Re: Notice of Violation
June 25, 2009

The following is the response by Cotter Corporation to the Notice of Violation (NOV) received June 25, 2009 for the inspection of May 4 through 6, 2009. The following are the listed violations, items of concern, recommendations and Cotter's response.

Cotter Corporation
Canon City Milling Facility

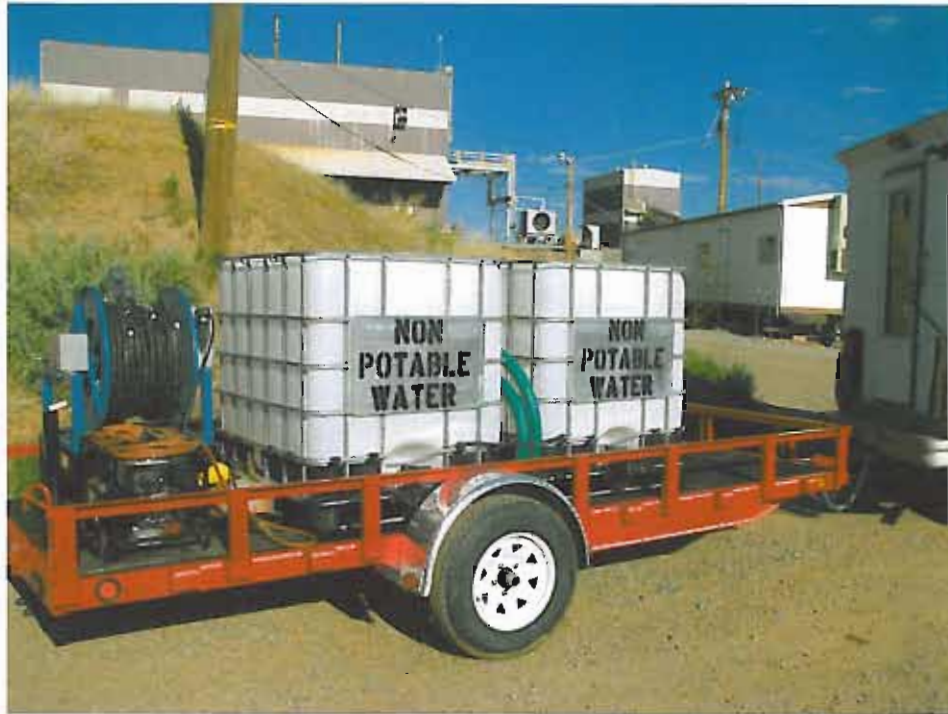
1. Birds are nesting and leaving droppings that are not being controlled in the buildings that are locked down. This may cause a health hazard when the buildings are accessed. This is not a radiation issue, but is of concern to CDPHE.

Cotter response: Cotter personnel are proceeding to secure against unauthorized bird entry on a building-by-building basis and have begun the wash down process on affected areas.
